AGENDA
PLANNING COMMISSION
116 WEST NEEDLES
BIXBY, OKLAHOMA
October 20, 2014 **6:00 PM**

**MINUTES
PLANNING COMMISSION
116 WEST NEEDLES
BIXBY, OKLAHOMA
September 15, 2014 6:00 PM**

To: Bixby Planning Commission
From: Erik Enyart, AICP, City Planner
Date: Thursday, September 11, 2014
RE: Report and Recommendations for:
PUD 12 – Conrad Farms Holdings, LLC &
PUD 85 – “Conrad Farms” – Conrad Farms Holdings, LLC &
BZ-377 – Conrad Farms Holdings, LLC

To: Bixby Planning Commission
From: Erik Enyart, AICP, City Planner
Date: Friday, September 12, 2014
RE: Report and Recommendations for:
BSP 2014-03 – “Brisbane Office Park” – Matt Means of StoreTulsa.com (PUD 60)

Exhibit A1 Site Development Area Southpark Self Storage

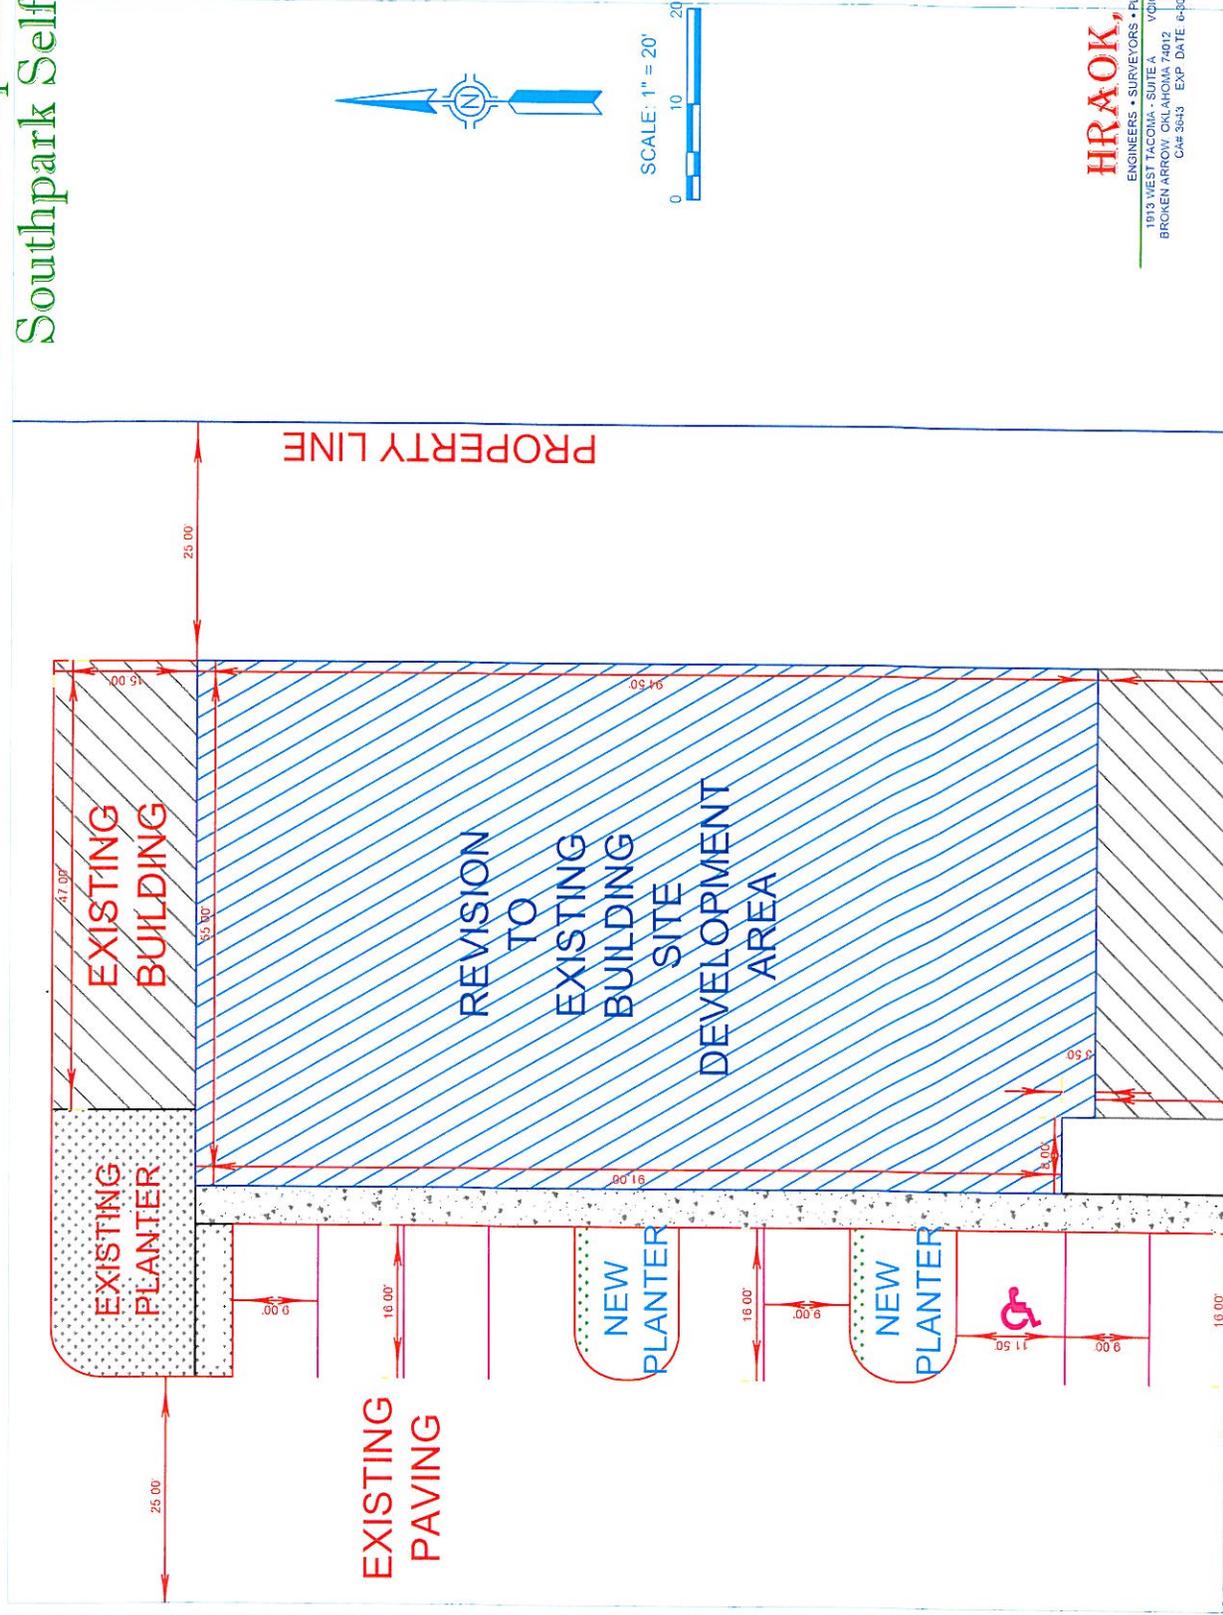
35. PUD Exhibit A1 (the first): Please show proposed fence and/or gate changes proposed as recommended by the Fire Marshal.
36. PUD Exhibit A1 (the first): Please reconcile with title as used in Table of Contents and as used in Exhibit A1 (the second).

37. PUD Exhibit A1 (the first): 16’ parking stall depths are not consistent with Bixby Zoning Code standards. Please provide for flexibility in this PUD, propose to restripe (at least the ministorage conversion development area) and revise site plan, or otherwise advise.

38. PUD Exhibit A1 (the first): One (1) ADA-designed parking space may not meet stall depth or access aisle standards of ADA. Please revise in accordance with ADA requirements.

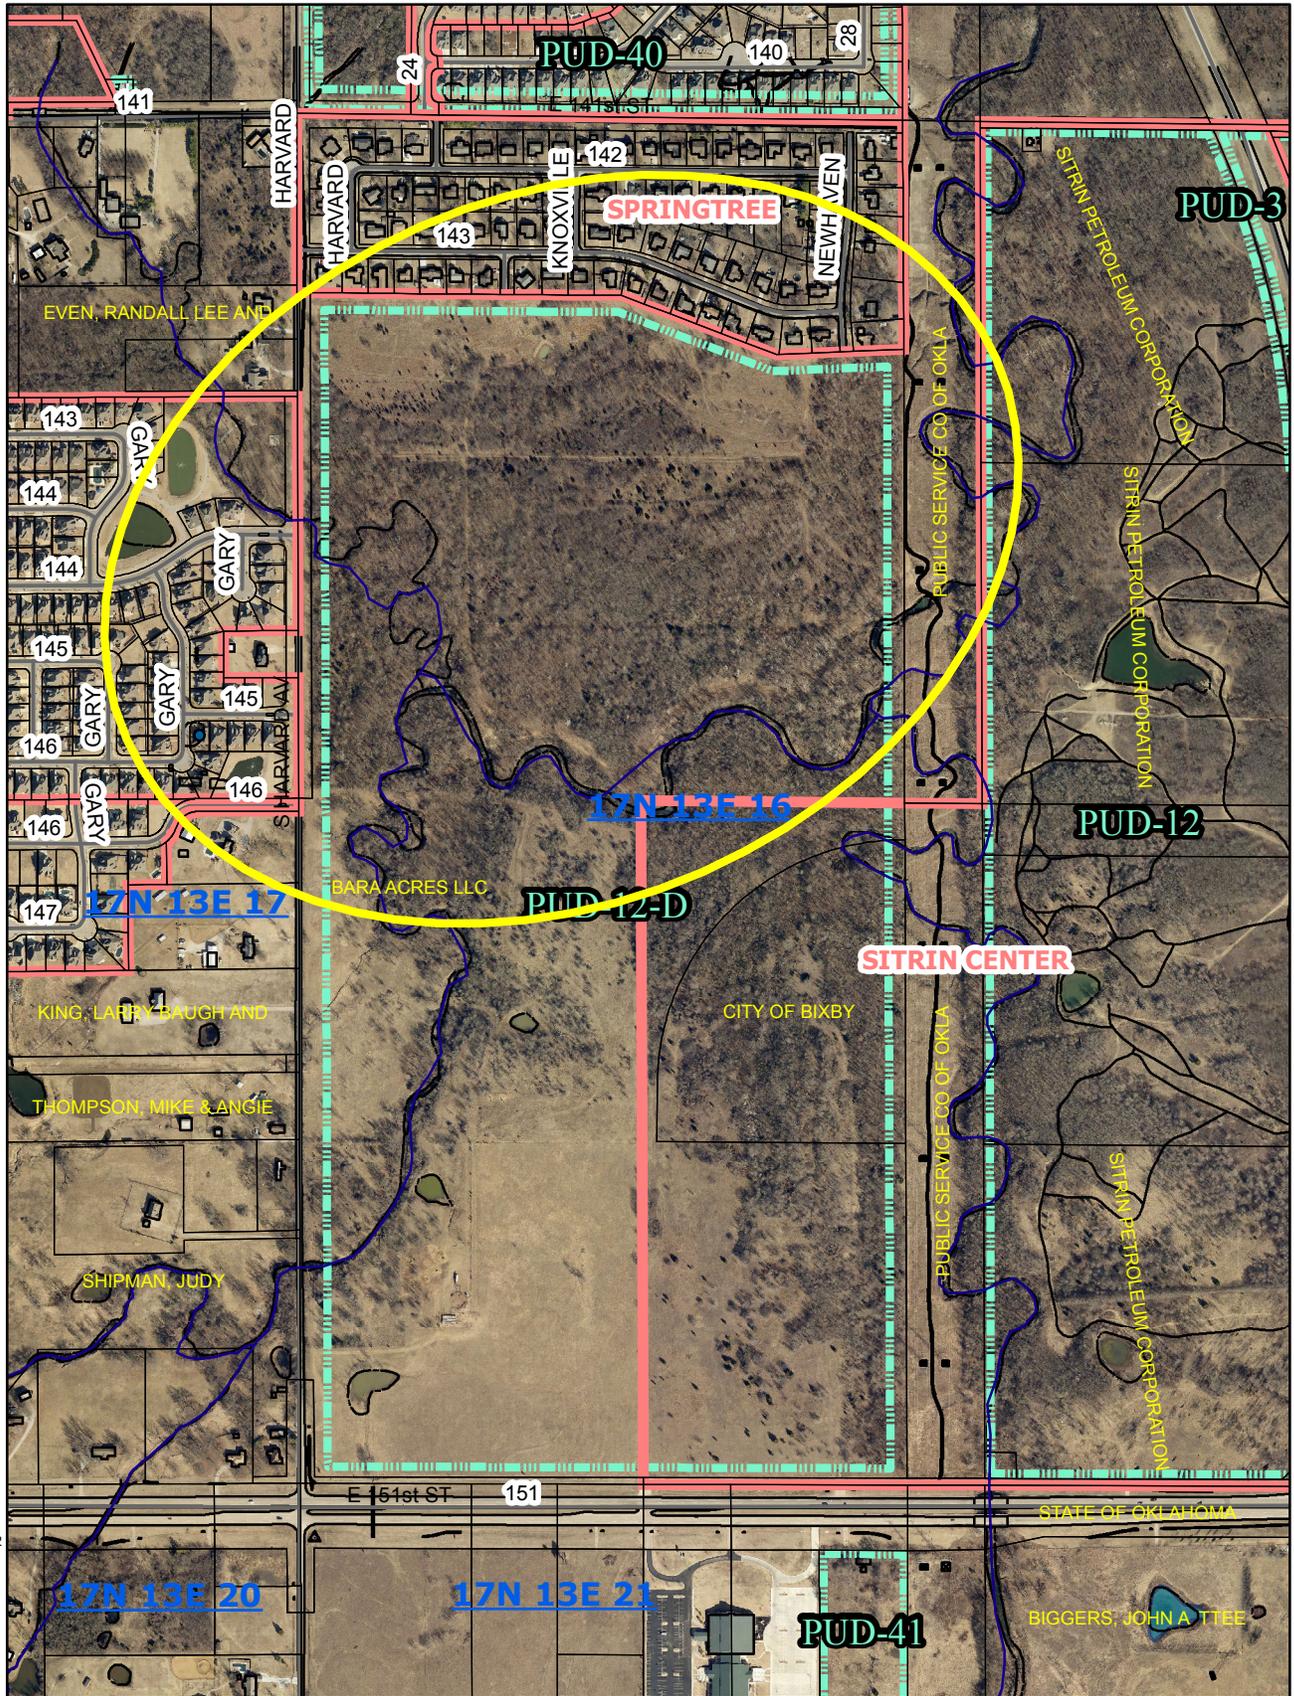
33. Please add proposed addresses to the lots. A table may be used if needed for map clarity.
34. Please consider using a different symbol to indicate the curve on the cul-de-sac turnaround just easterly of the Reserve Area C frontage, to avoid ambiguity with curve # 1 as shown in the Curve Table.

35. Lots 8, 9, and 10, Block 6, are completely separated from the balance of Block 6 by Reserve Area A. Per the definition of "Block" in the Subdivision Regulations and the typical block numbering conventions, the two (2) areas need to be separate blocks.

36. Lots 5 through 9, inclusive, are completely separated from the balance of Block 6 by a street. Per the definition of "Block" in the Subdivision Regulations and the typical block numbering conventions, the two (2) areas need to be separate blocks.
